**MIAMIBEACH**  
**PLANNING DEPARTMENT**  
Staff Report & Recommendation

Historic Preservation Board

SUBJECT: **HPB25-0667, a.k.a HPB20-0442, 100 21<sup>st</sup> Street**

An application has been filed requesting modifications to a previously issued Certificate of Appropriateness for the partial demolition, renovation and restoration of the hotel building, the total demolition of an accessory cabana structure, the construction of ground level and rooftop additions, one or more waivers and a variance to relocate signage to a non-street facing façade. Specifically, the applicant is requesting to exceed the scope of the previously approved demolition.

Figure A: Additional Demolition of North Façade

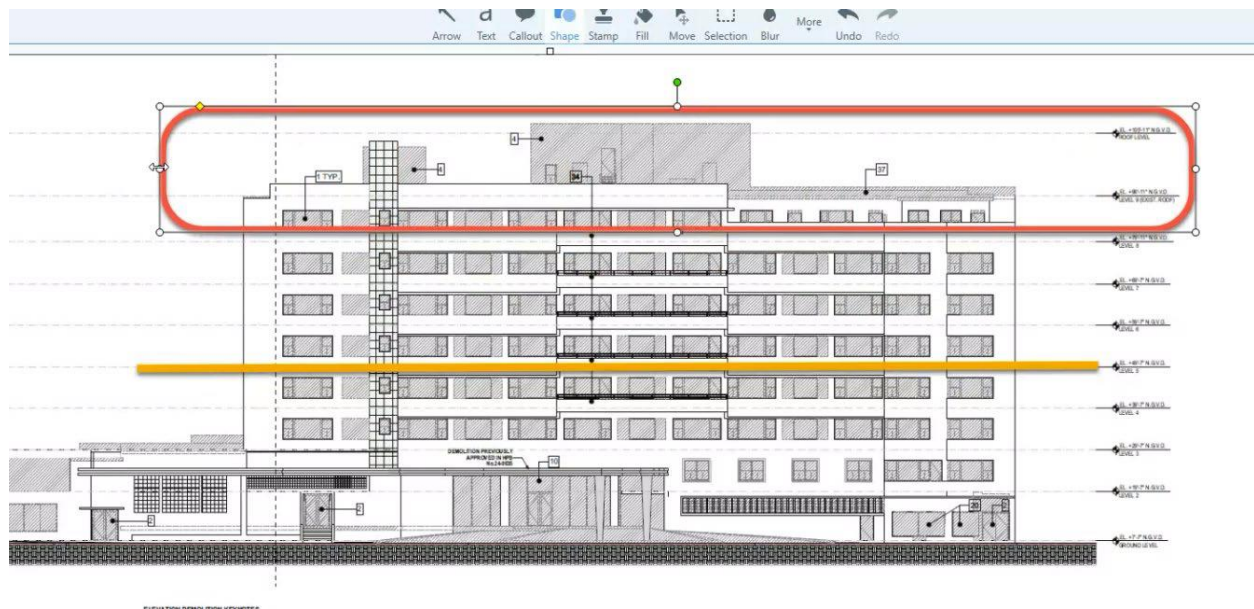
As indicated by the applicant, “after the last HPB approval for additional demolition, HPB 25-0649, the construction and engineering teams returned to work on the Property; however, during the demolition process the team noticed an unexpected amount of vibrations throughout the building and immediately ceased work to protect the staff on site and anyone near or around the construction site. Through this experience and further analysis, the structural engineer determined that it is impossible to safely support seven floors of the north façade without the possibility of an imminent collapse, potentially endangering both the workers on site and risking debris falling into the public right-of-way. The engineering team presented its findings to the Building Official noting the additional demolition of the top three floors would remove the weight of those floors and thereby reduce the wind loading on the façade, and preserve the remaining bottom four floors. This is shown below on the annotated elevation from the HPB 25-0649 plans:”

The applicant’s letter of intent continues “In Figure A above, the area outlined in red is already approved for demolition, the line in yellow is up to where the structural engineer concluded that we could safely preserve and support the north wall of the building.

On July 14, 2025, the Building Official issued a memorandum supporting the structural engineer’s conclusions and recommending the removal of the additional three floors from the top of the north façade to provide for the best possible success of the project and safety of the workers. Both the structural engineer’s letter to the Building Official and the Building Official’s memorandum are included with this Application.”

At this point the building has remained vacant for several years, and there is currently an active building permit for the project. Staff continues to believe that expediting the property’s return to active use will greatly benefit the quality of life and character of the surrounding historic district. Based upon the latest evidence presented, and the safety concerns expressed, staff has no objection to the increased scope of demolition.
